DEVIATION REQUEST AND DECISION FORM

Project Name: Sterling Ranch - CDR 20-005 Vollmer, Marksheffel and Sterling Ranch Rd. Construction Drawing Review

A deviation from the standards of or in Section ECM section 2.2.4 Roadway Functional Classifications of the	Engineering Cri	teria
Manual (ECM) is requested for the Marksheffel Road Right of Way and cross section.

TYPICAL SECTION
MARKSHEFFEL ROAD
STERLING RANCH FIL 2
JOB NO. 2518801
JAN, 26, 2021
SHEET 1 OF 1

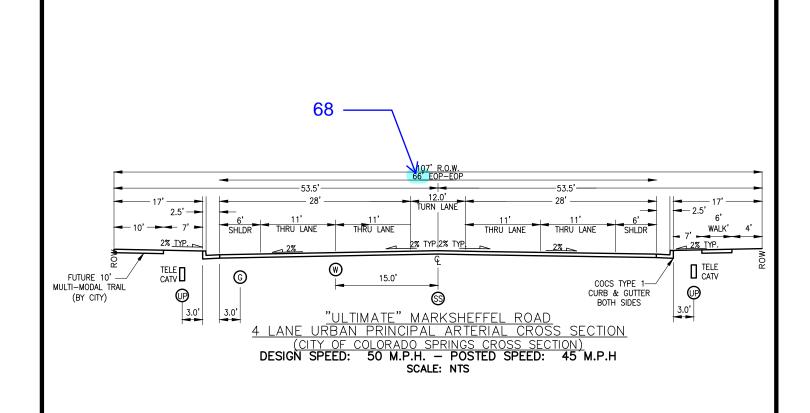
- 1. El Paso County will not maintain Marksheffel Road with the proposed design, and will only facilitate approvals and coordinate transfer of the road, upon completion of construction, to the City of Colorado Springs. Ultimate plan approval, notice to proceed, and MS4/stormwater enforcement remains under the County's jurisdiction until such time that the road is actually annexed into the City.

- 2. Construction of the approved cross-section (above) is at the developer's risk as the County cannot guarantee City acceptance of the road and associated deeds. Any revisions necessary to meet County requirements due to a change in City commitments will be the developer's responsibility.

- 3. The City may require construction of the full four-lane cross-section from Vollmer Road southeast along platted areas (Sterling Ranch Filing No. 2).

- 4. The City may require a 25% escrow contribution to the traffic signal at Vollmer Road.
- 5. The intersection at Vollmer Road shall be designed and constructed to allow for realignment of Tahiti Drive from the northwest at an appropriate location entering the new intersection.

- 6. Any additional easements necessary for drainage, slope easements and other public improvements shall be shown on plans as "public improvements easements." If these easements are required, they shall be provided by separate recorded document (non-exclusive public easements) approved by El Paso County and referenced on the plans prior to plan approval.

- 7. A 25-foot non-exclusive County trail corridor easement is required along the northeast side of Marksheffel Road and shall be shown on all plans. It is assumed that this corridor will remain under County Jurisdiction.
